## APPENDED HEALTH AND SAFETY PLAN FOR TASK ORDER 1

### RCRA Facility Investigation/Corrective Measures Study (RFI/CMS) and Base Closure Environmental Study for the Lexington-Blue Grass Army Depot

AMENDMENTS/CLARIFICATIONS/ADDITIONS TO THE HEALTH AND SAFETY PLAN

Figure  
3-1

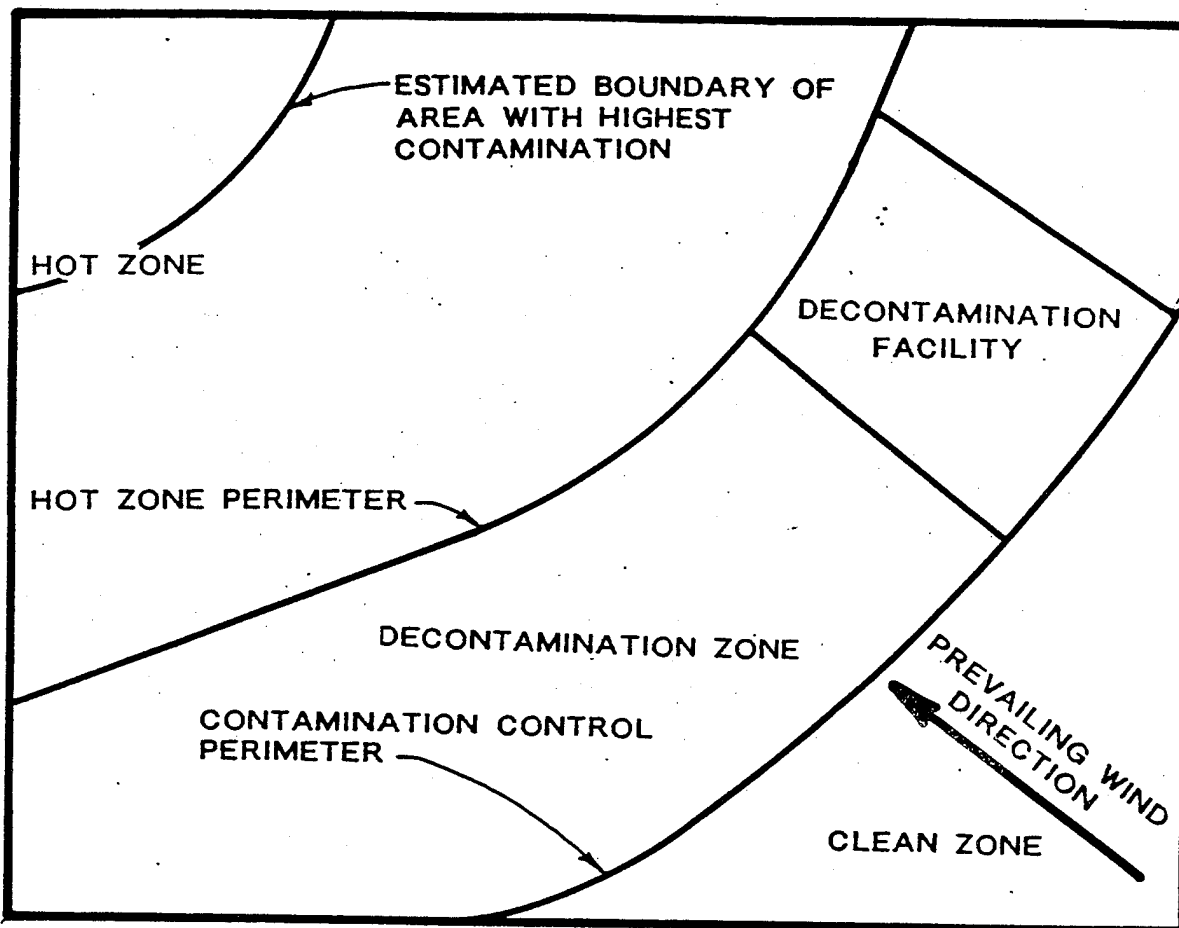
Change: Insert "Figure 3-1 is an example of Work Zone Designation" as the 3rd Paragraph.

Change: Insert Figures 3-1 and 3-2.

Figure  
 3-2

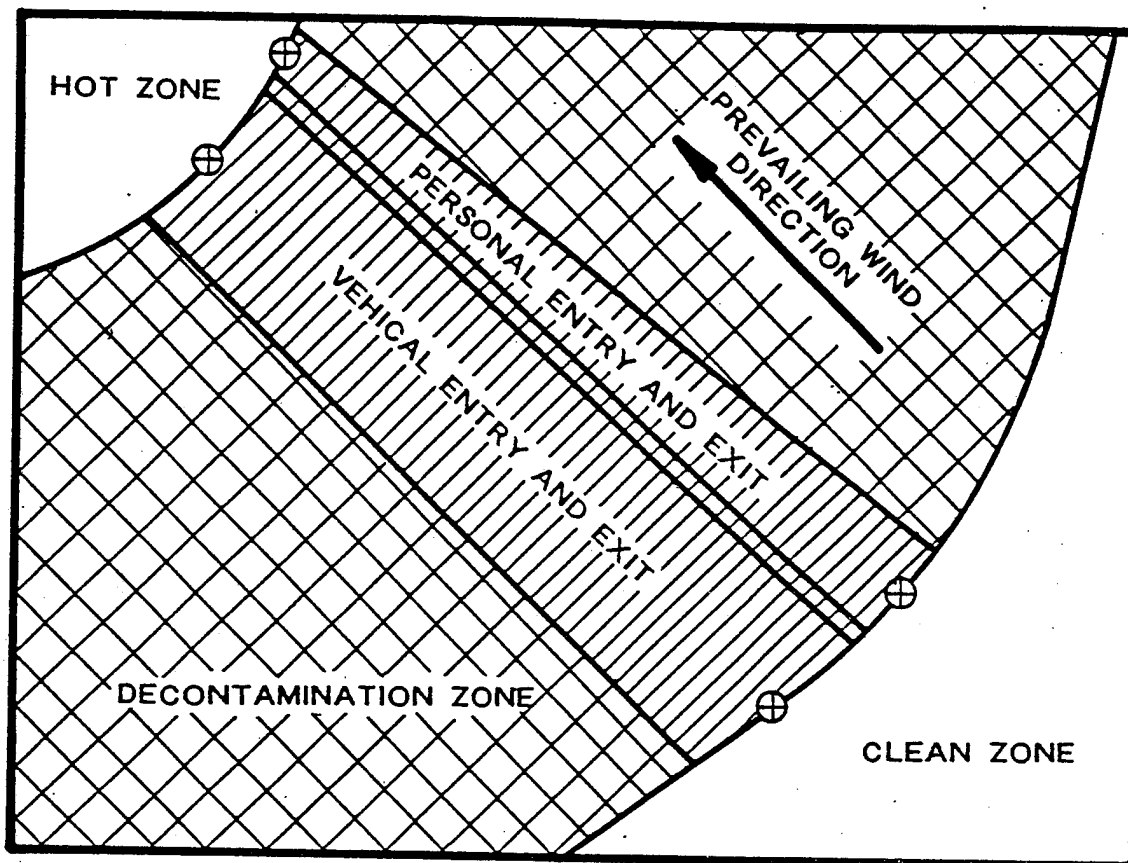
Change: Insert "Figure 3-2 is an example of a Contamination Reduction Zone" after the 8th Paragraph.
